## MEMORANDUM

**Re:** WRSP PCL F-25 & F-26 Fiddymment Bungalows – Response to Neighbors Letter

**Figure 1. Architectural Comparison to Existing Homes**

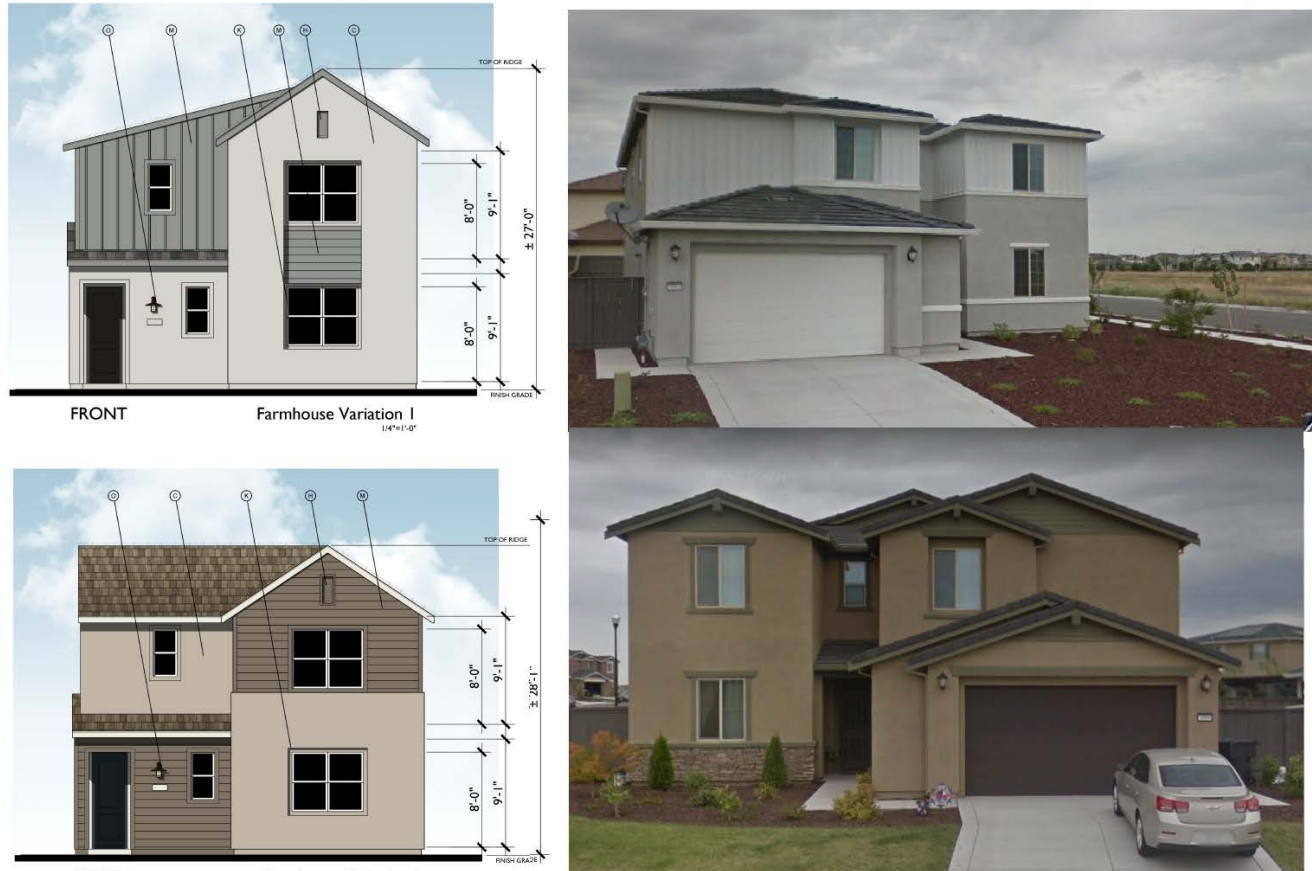
There are 6 color schemes proposed for the project. The letter refers to a “reflective” white color. One of the six base colors, Sherwin Williams Greek Villa, could be considered an off-white and it is not reflective. Farmhouse architectural style is used throughout the project. This style combines modern and traditional features, which are complementary to homes in the immediate area. Community Design Guideline MF-27 calls for multi-family projects to complement the context of adjacent and surrounding projects, but to avoid duplication in design. Copycat architecture is discouraged. Staff compared the proposed architecture and colors for the project to existing homes in the immediate vicinity of the project (Figure 1). The top image compares one of the variations of Plan 3 in the project to the existing home at 4065 Chuckwagon Wy. located across the street from the project site. Complementary features include the two-story height, color scheme, base material of stucco, and vertical accent siding. The bottom image compares another variation of Plan 3 to an existing home at 5024 Stetson St. located approximately 160 feet from the project site. Complementary features include the two-story height, earth tone color scheme, base material of stucco, and horizontal accent siding. While the Farmhouse style is not a copy of any existing home in the area, there are a number of complementary colors, materials, and architectural features that meet the intent of the Community Design Guidelines.
